Minutes
of
55th PCC meeting

EASTERN REGIONAL POWER COMMITTEE

MINUTES OF 55TH PROTECTION SUB-COMMITTEE MEETING HELD AT ERPC, KOLKATA ON 25.05.2017 (THURSDAY) AT 11:00 HOURS

ITEM NO. B.3: Disturbance at 220/132 kV Lakhikantapur S/s (WBSETCL) on 26-04-17 at 16:16 Hrs.

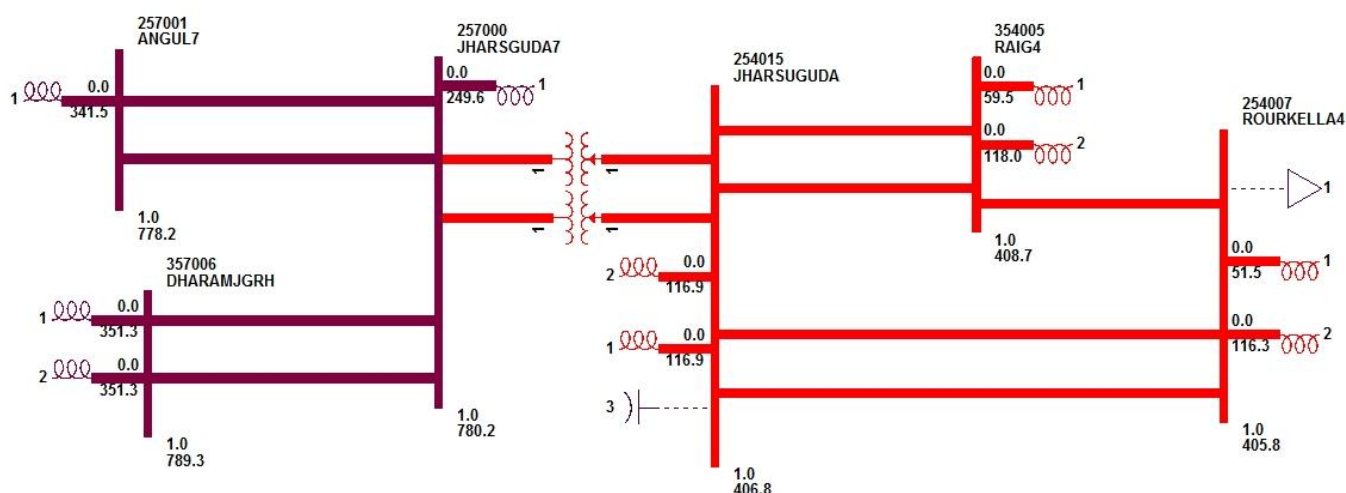
WBSETCL may explain the following:

- Reason for delayed fault clearing of 1 s

WBSETCL explained that first a Y-ph fault initiated at 132kV Lakhikantapur due to failure of tension disk insulator and 220/132 kV ATR - II cleared the fault on differential protection within 100 ms. Later jumper fell on 132 kV main bus resulted in three phase fault. The fault got isolated by over current E/F protection at HV side of 220/132 kV ATR –I & III in 900 msec. WBSETCL added that 2500 A fault current was observed by each ATR and the O/C, E/F protection operated correctly as per the IDMT characteristics.

ERLDC informed that damped power flow oscillations were observed in 400 kV Jeerat – Subhasgram S/C and 400 kV Durgapur – Maithon – I for around 5 sec after the fault clearance.

ITEM NO. B.4: Disturbance at 765 kV Jharsuguda (PG) S/s on 19-04-17 at 15:45 Hrs.

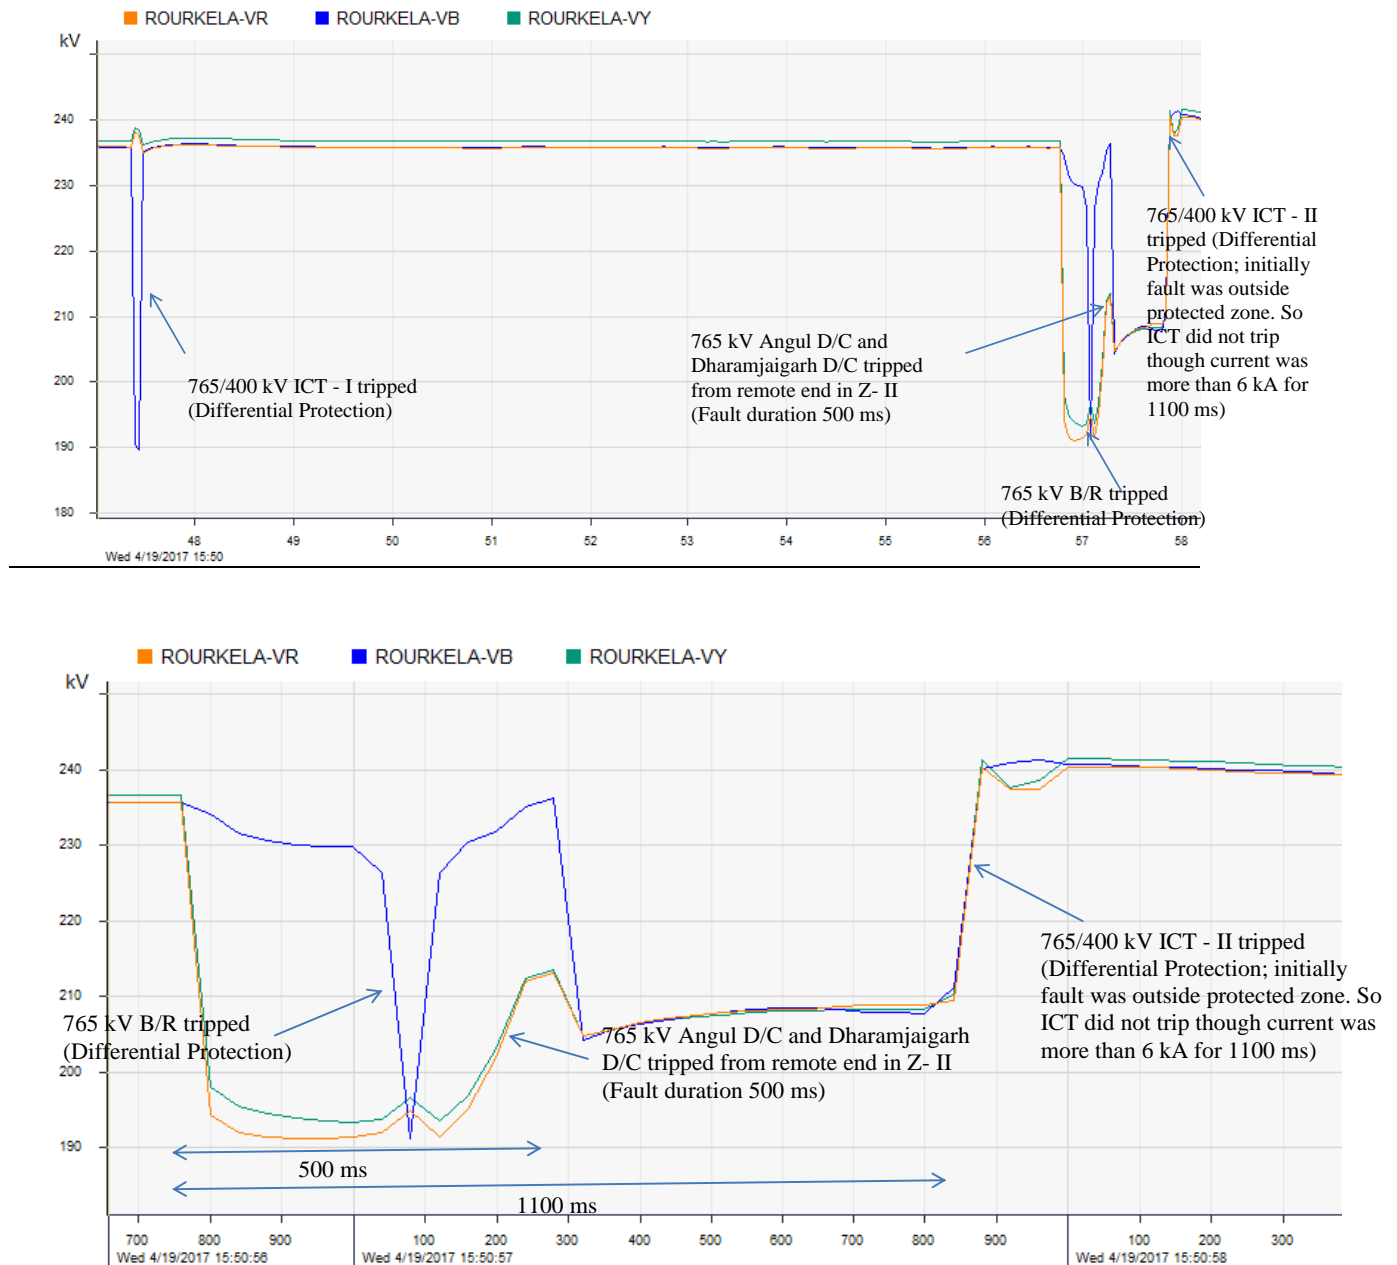
Powergrid may explain the following:

- It was informed that bus differential protection at 765kV Jharsuguda did not operate due to problem in DC system. How ICT and Bus reactor tripped at 765kV Jharsuguda on differential protection.
- 765 kV Jharsuguda – Angul – I & II and 765 kV Jharsuguda – Dharamjaigarh – I & II tripped from remote end on zone 2 in 500 ms. Zone 2 time should be 300 ms.

Powergrid explained the bus bar protection master control units (MCUs) were changed to error mode while interchanging the DC incoming cable of 724 RA/RB panel by isolating both DC-1 and DC-2 from DCDB. As a result bus bar protection was not operated.

Powergrid informed that zone 2 time settings 765 kV Jharsuguda – Angul – I & II lines at Jharsuguda end was kept at 500 ms to coordinate with adjacent short line.

ITEM NO. B.10: Tripping of 220 kV Muzzaffarpur - Hazipur D/C line on 13-04-17 at 15:03 hrs.

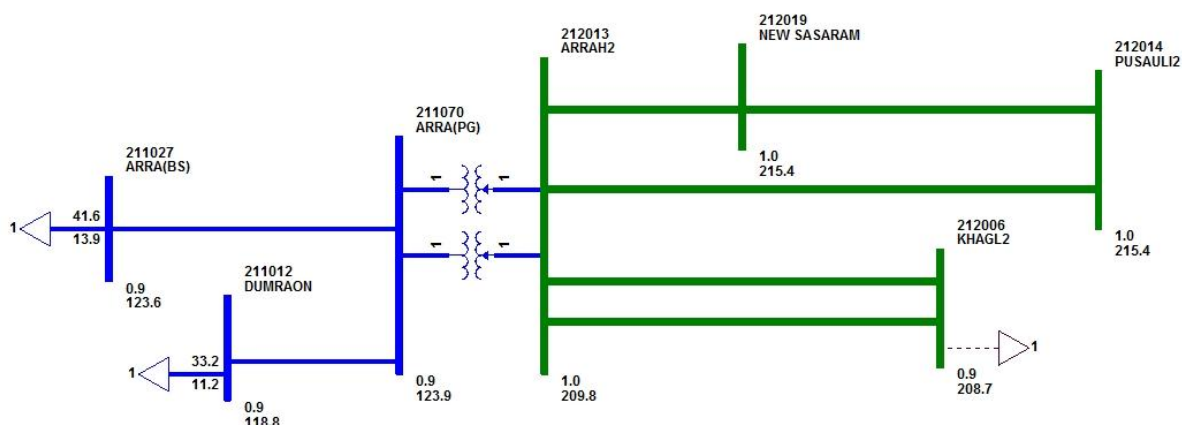
Powergrid and BSPTCL may explain.

Powergrid informed that 220 kV Muzzaffarpur - Hazipur D/C line tripped from Muzzaffarpur end on zone 2 due to phase to phase fault at the instant of charging of newly constructed 220 KV Hajipur - Amnaur ckt-2 transmission line.
